NEBRASKA PUBLIC POWER DISTRICT
COOPER NUCLEAR STATION
QUALITY ASSURANCE PROGRAM FOR OPERATION
POLICY DOCUMENT
TABLE OF CONTENTS

FIGURE 1
Nebraska Public Power District
NUCLEAR POWER GROUP
QUALITY ASSURANCE DIVISION

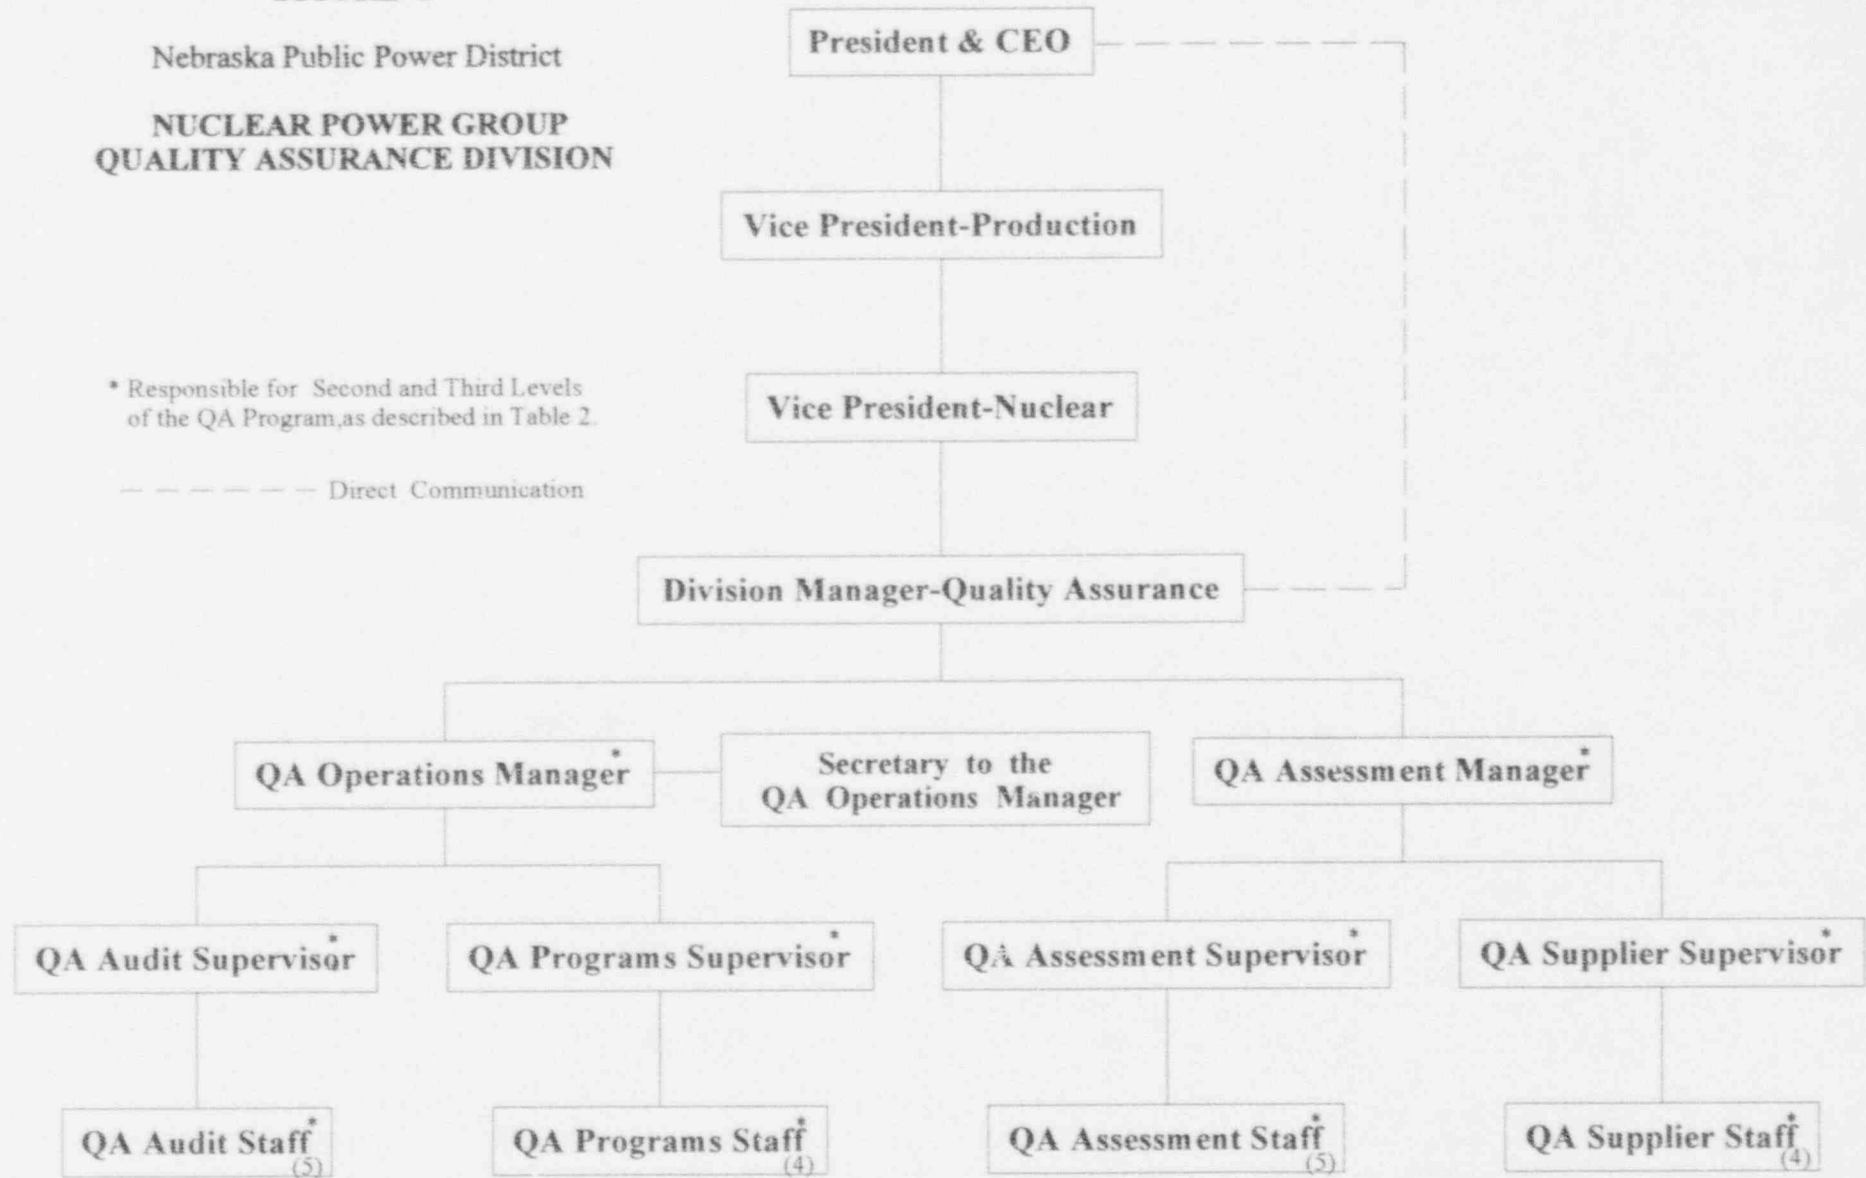
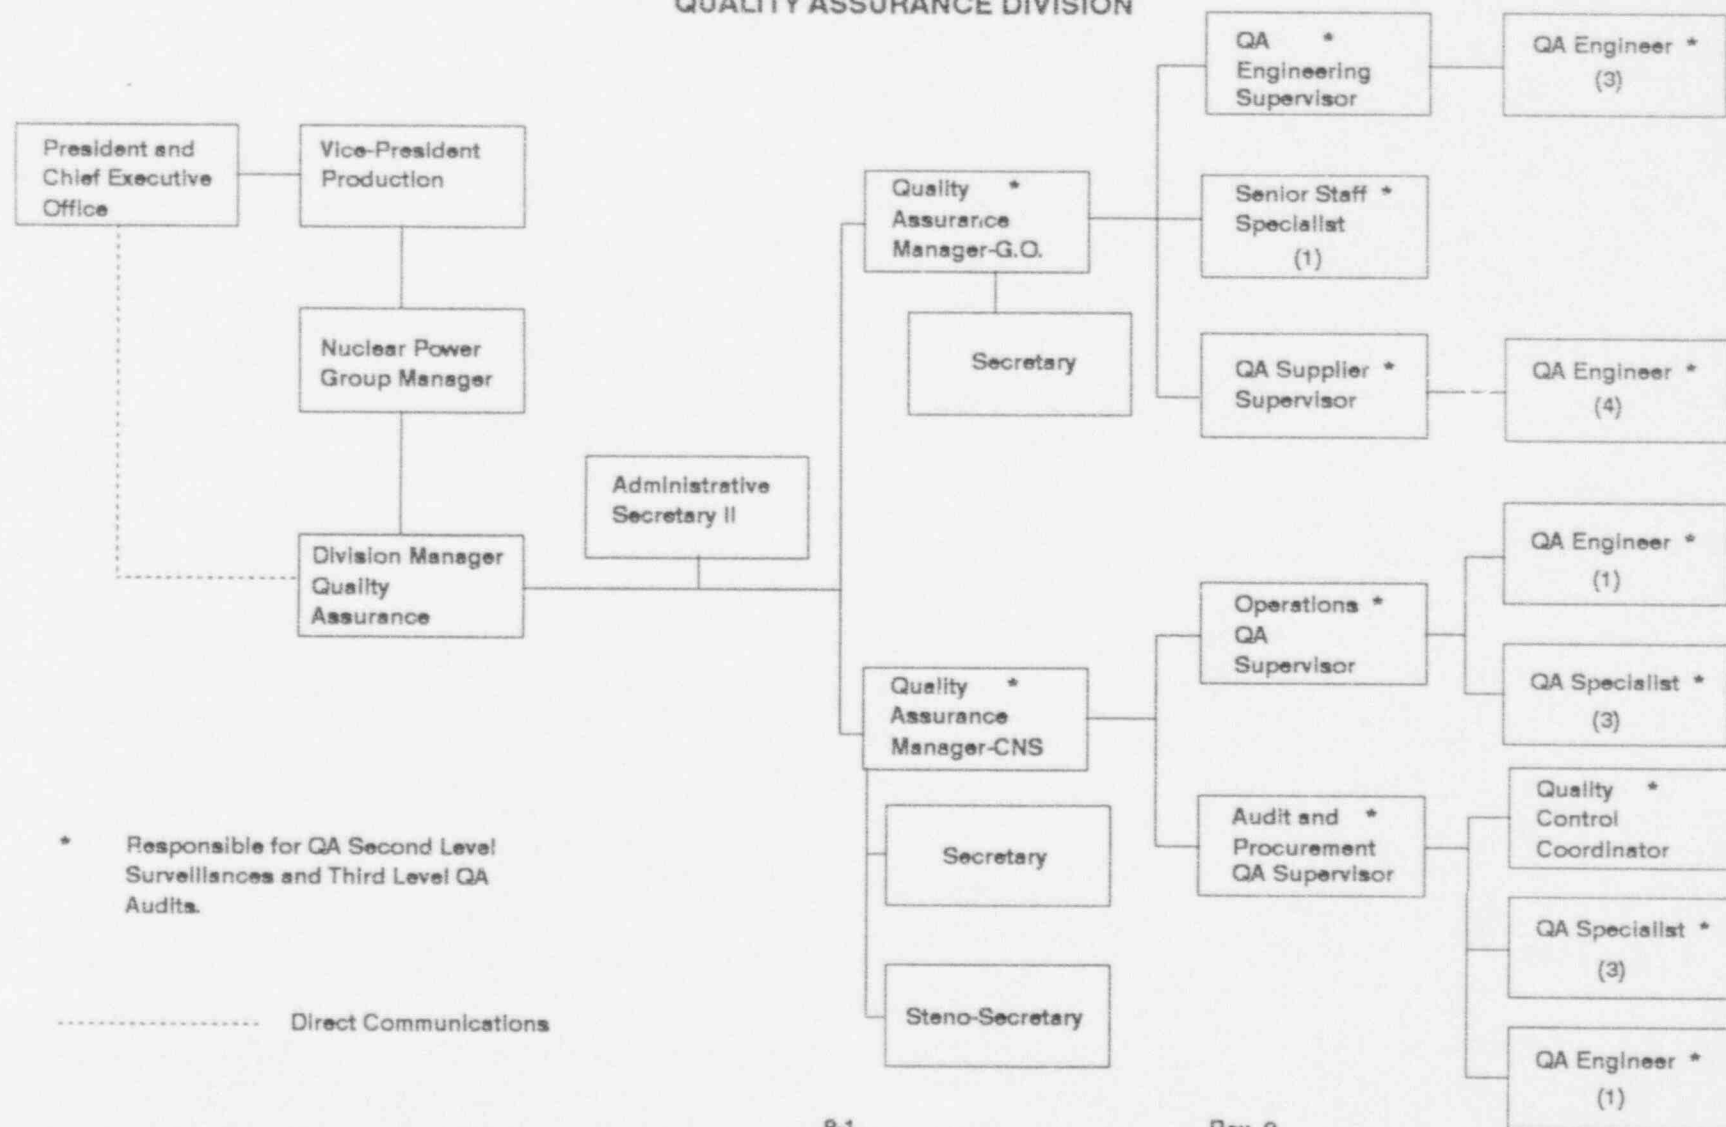
| PAGE | CHANGE | COMMITMENT REDUCTION |
|------|---|-------------------------|
| 8-1 | <p>Figure 1 was revised to reflect organization changes as previously described in various sections of the text. These changes do not constitute a reduction in commitment or NPG Management responsibilities.</p> | No |
